RE: Crocker Village Flex Zone (DR16-329) Revised

WALKSacramento has reviewed the Crocker Village Flex Zone (DR16-329) Revised project routing. The revised project is essentially unchanged, although an important walkway has been added. The principal streets on which the project is sited, Crocker Drive and 10th Avenue, do not play much of a part in the building's siting and function. The Crocker Drive and 10th Avenue intersection, which is practically a gateway to Crocker Village commercial areas and the City College bridge, doesn't play a part in the project. While the project may need to serve customers arriving via autos, the project should have a major focus of serving those arriving on foot and bike, but it doesn't.

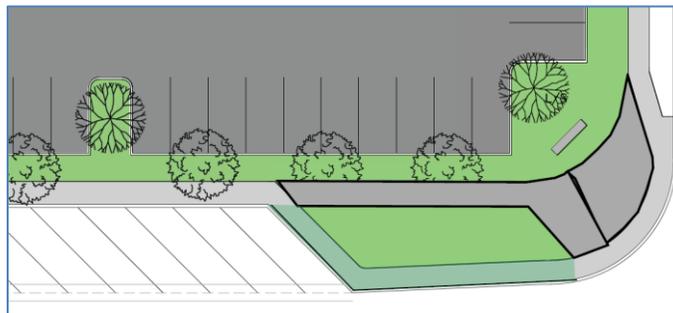
The landscape planter between the parking lot and the sidewalk on 10th Avenue appears to be less than 3' wide.

We recommend realigning the sidewalk and expanding the pedestrian landing area at the corner to create a more direct path around the corner. See the diagram below.
